**Thu 15b**Staff: LRO-SD
Staff Report: 9/27/01
Hearing Date: 10/9-12/01STAFF REPORT AND RECOMMENDATION ON APPEAL

Application No.: A-6-LJS-01-95

Description: Removal of unpermitted improvements on face of coastal bluff and construction of pool with spa, concrete deck, retaining walls, drains, landscaping and dedication of an emergency access easement along southern edge of 1.31 acre blufftop lot containing a single family residence.

Site: 7957 Princess Street, La Jolla, San Diego, San Diego County.
APN 350-151-01 & -02

EXHIBIT NO. 2
APPLICATION M
A-6-LJS-01-95
Site Plan

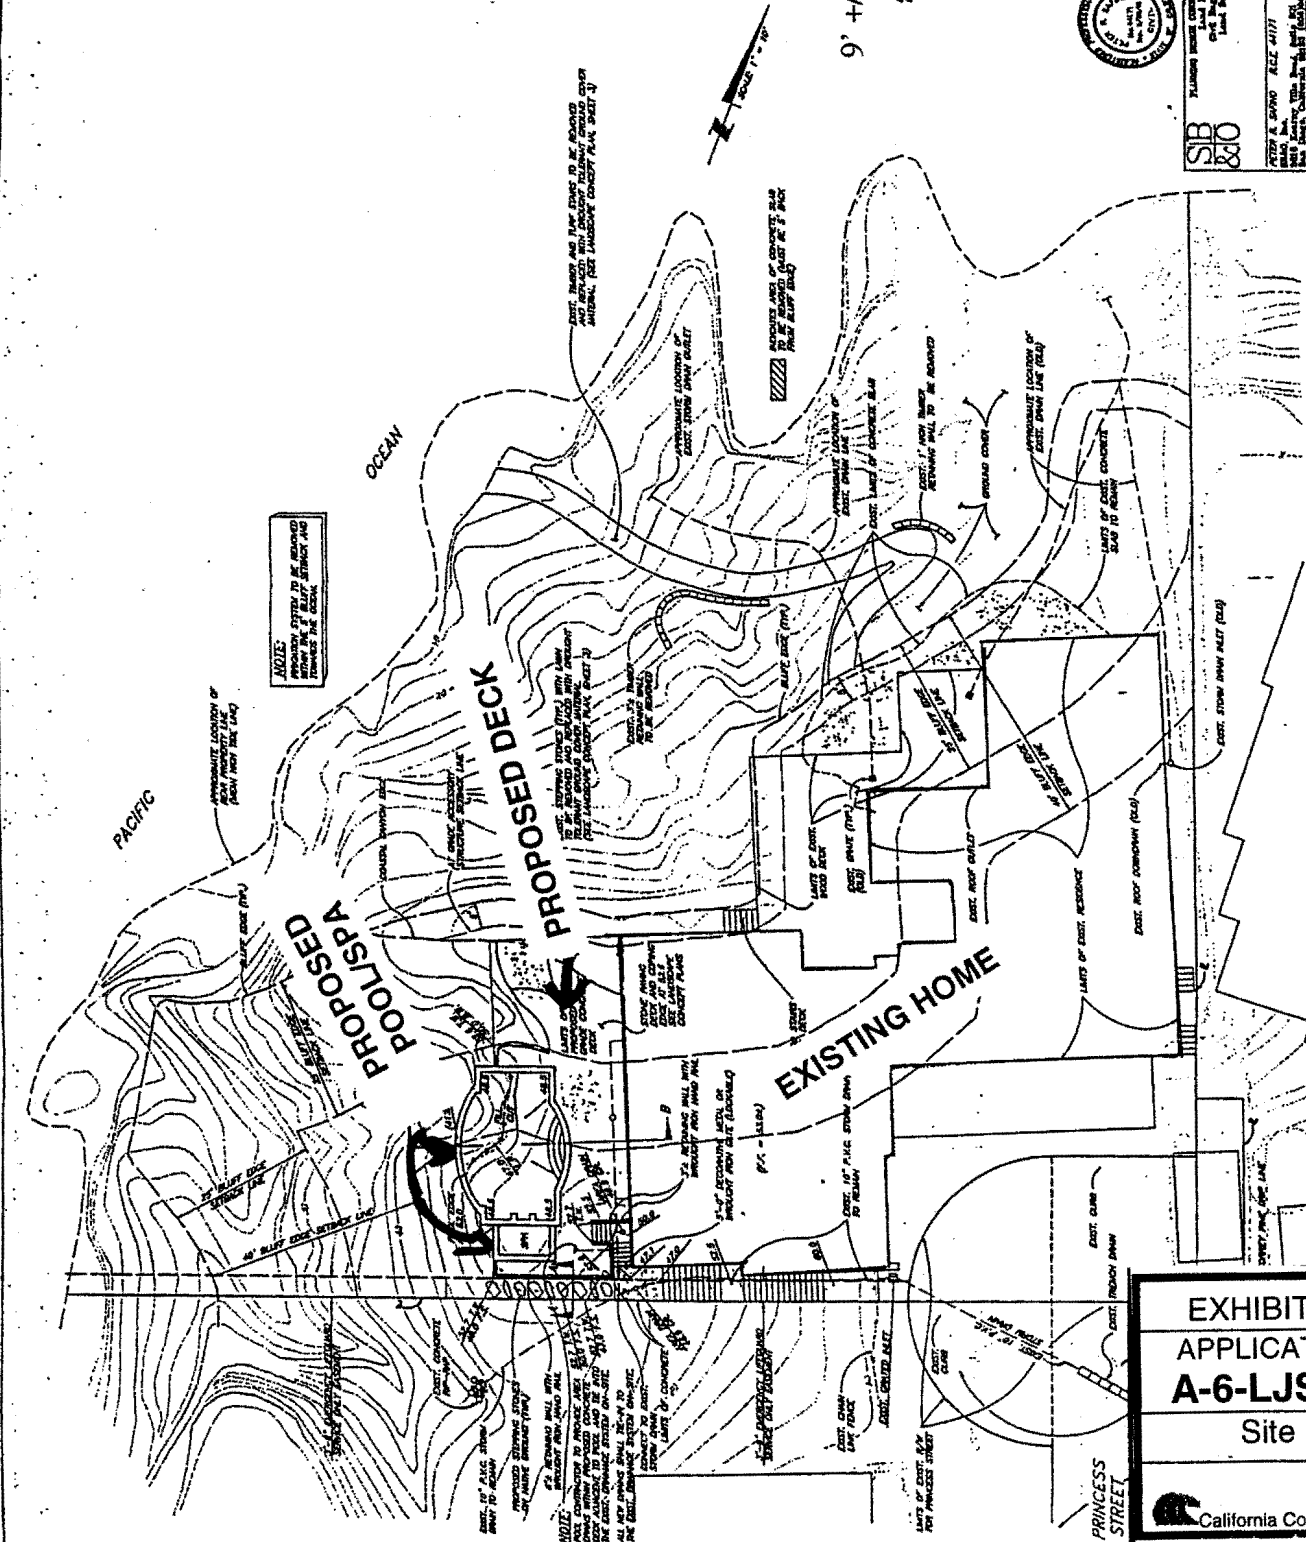
2. Shoreline Hazards/Alteration of Landforms/Scenic Quality. The proposed development involves the removal of a number of existing unpermitted improvements (wooden timber stairs, retaining walls and palm trees) on the face of the coastal bluff and construction of a pool with spa, a concrete deck, barbecue counter, retaining walls, drains and landscaping in the rear yard of a single-family residence. The location of the subject site where the proposed pool and spa are to be located is seaward of the residence on a very steeply sloping portion of the site. The pool will be cut into the slope and then supported by an approximately 9-12 ft. high retaining wall on the western facing portion of the slope (ref. Exhibit #2).

EXHIBIT NO. 6
APPLICATION NO.
A-6-LJS-01-95
Approximate Bluff
Edge Per
Commission's
Geologist

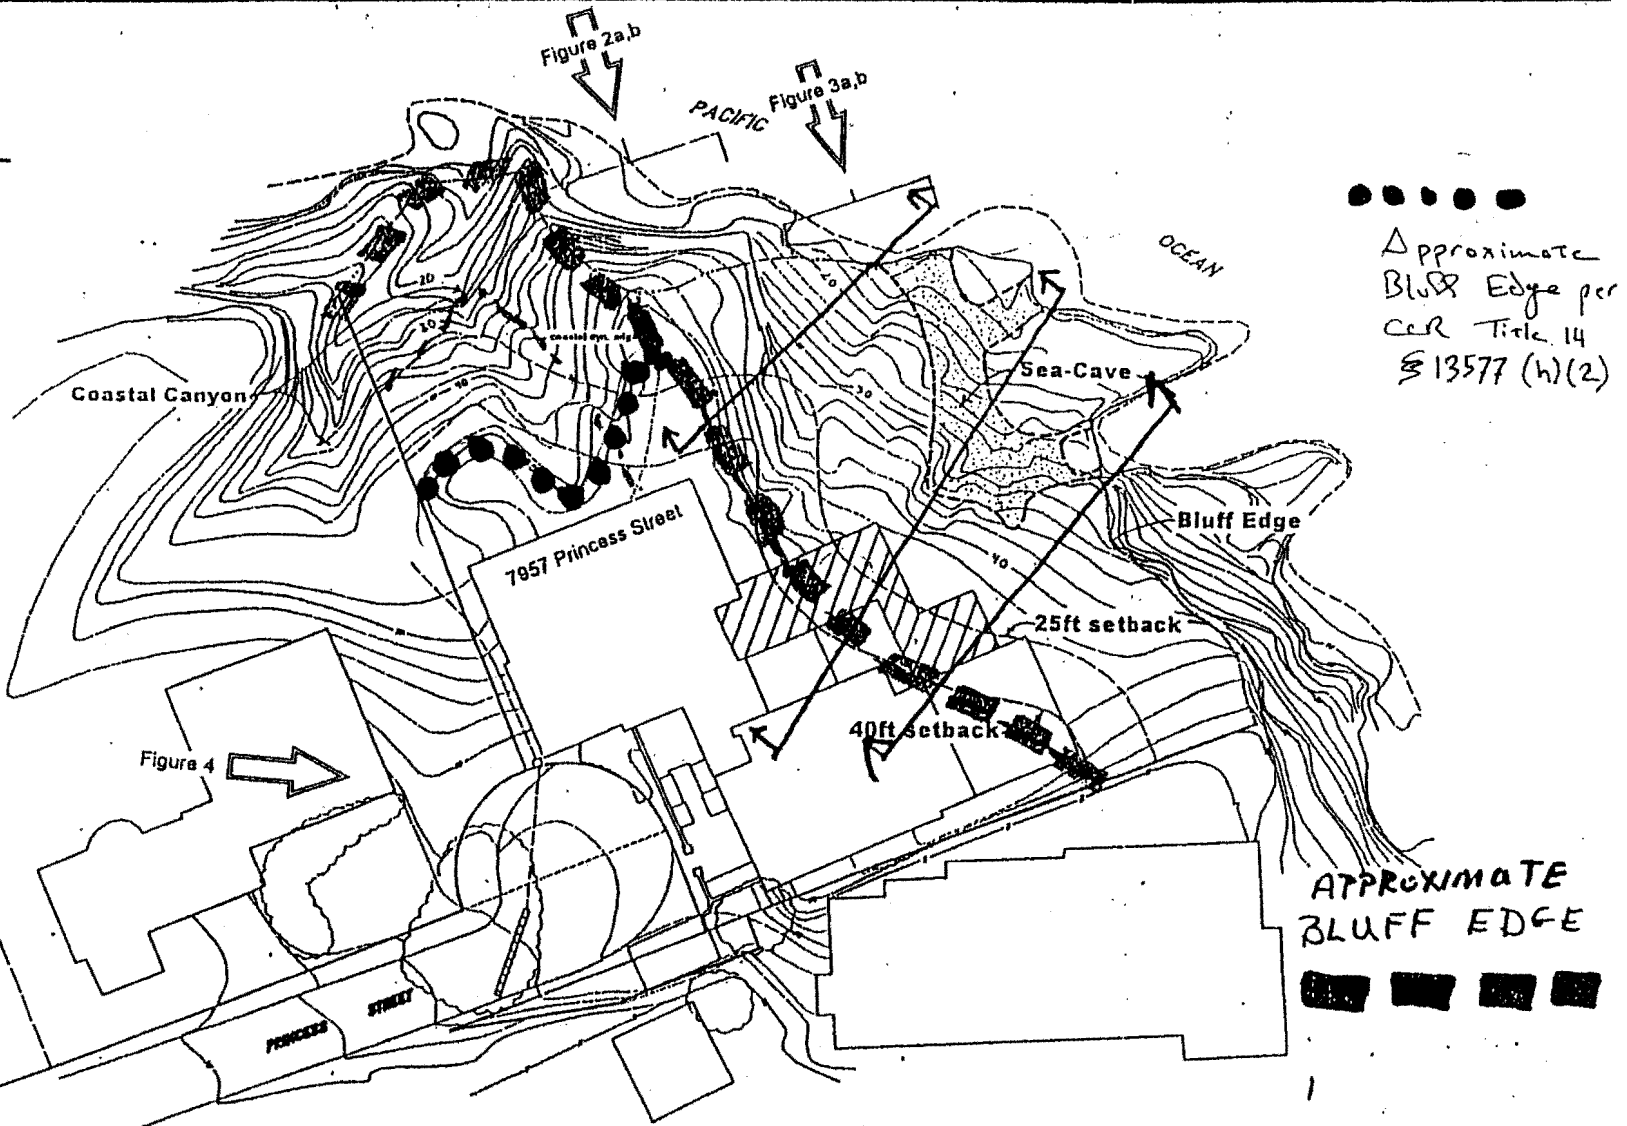
The Commission staff's geologist has further stated that under the Coastal Act definition of a bluff edge, the edge would be defined as the break in slope immediately southwest of the subject residence where the "downward gradient of surface increases more or less continuously until it reaches the general gradient of the cliff". The City's LCP (former municipal code) contains a similar definition as that cited in the Coastal Act.

The Commission's staff geologist has also drawn an exhibit (reference Exhibit #6) that approximates the location of the bluff (dotted line) edge pursuant to the definition of bluff edge as defined in the California Code of Regulations which is essentially the same as that contained in the certified LCP. As can be seen from the exhibit, the proposed pool and spa would be located entirely beyond the bluff edge. Thus, based on the current standard of review the proposed improvements are thus proposed seaward of the delineated bluff edge on the face of the coastal bluff, which is inconsistent with the above-cited LCP provisions.

EXHIBIT NO. 7
APPLICATION NO.
A-6-LJS-01-95
Coastal Canyon-
From Beaches and
Bluffs Guidelines

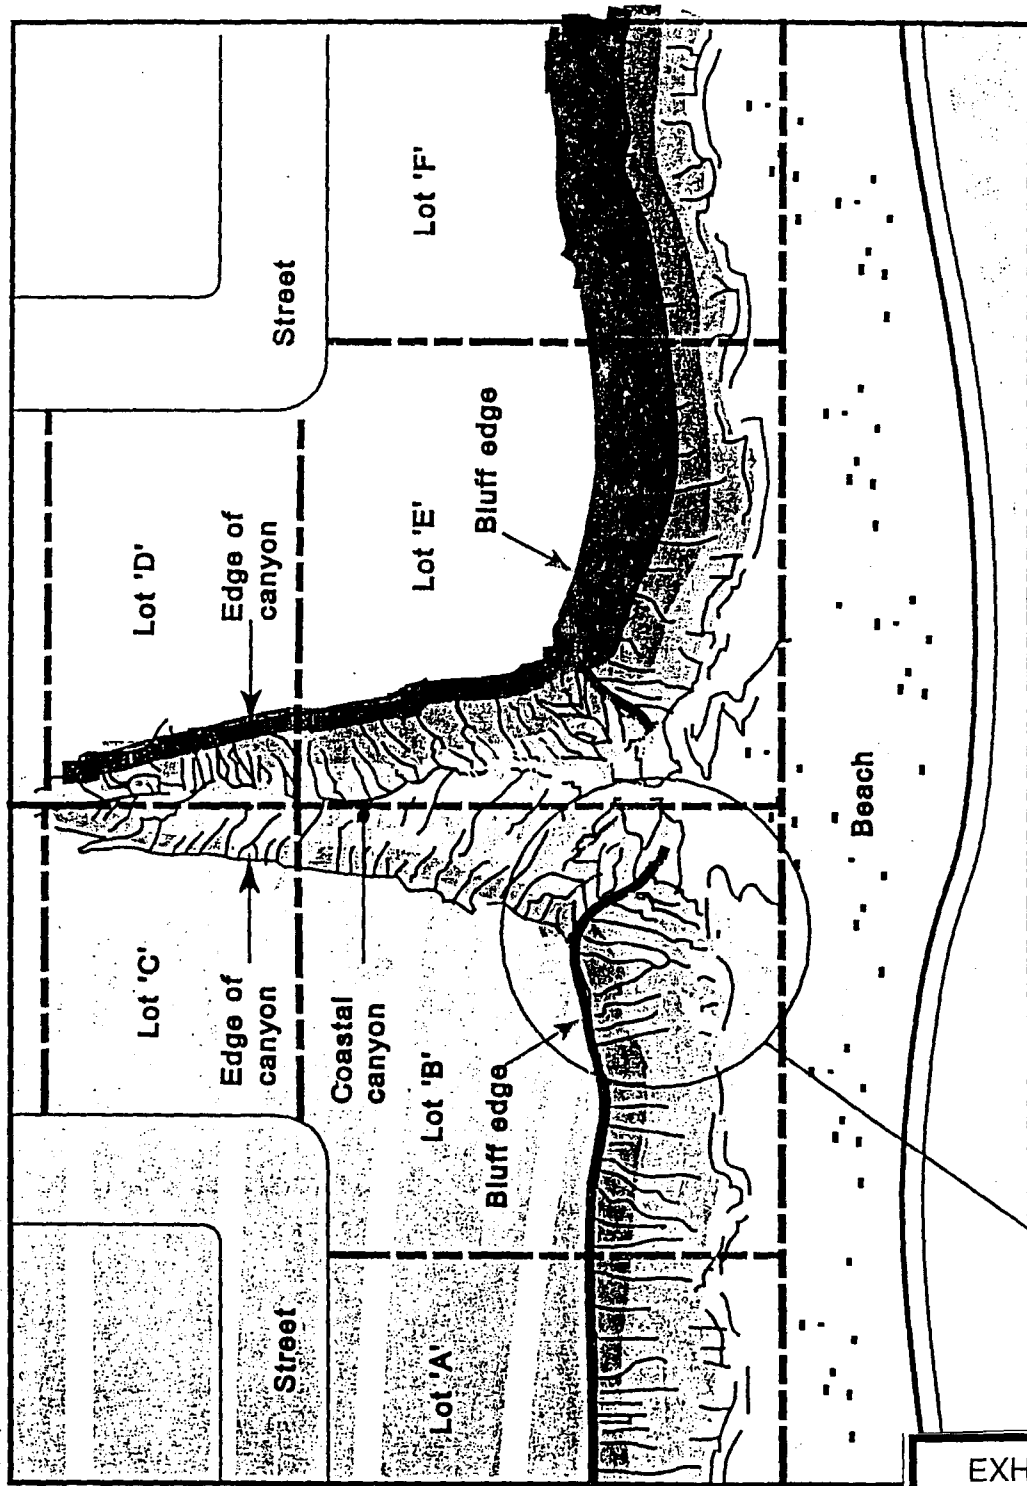
Where a site is bounded on at least one side by a coastal canyon (a large, established regional drainage course that traditionally accepts runoff from offsite), the coastal bluff edge is defined as the portion of the site which drains directly to the ocean. The portion of the site which drains first to the canyon (landward of the drainage divide) is not considered to be a sensitive coastal bluff. [ref. Exhibit #7]

In order to assess the issue whether the site actually contains a portion of a coastal canyon, Commission staff visited the site. Upon site inspection by Commission staff, it appears that the "coastal canyon" that the City describes as part of the southern portion of the site is more accurately described as a small gully on the face of a coastal bluff that accepts drainage from a couple of home sites and the small street adjacent to the subject site. In addition, while it does accept some runoff from offsite, the Commission does not agree that the area should be classified as a "large established regional drainage course". Also, the "coastal canyon" does not outlet directly onto the beach, but outlets on the face of the coastal bluff on the subject site, where the toe is subject to marine erosion at all but the lowest tides. As can be seen in a photograph of the site taken by Commission staff (ref. Exhibit # 8), the toe of the slope is subject to wave action and marine erosion.
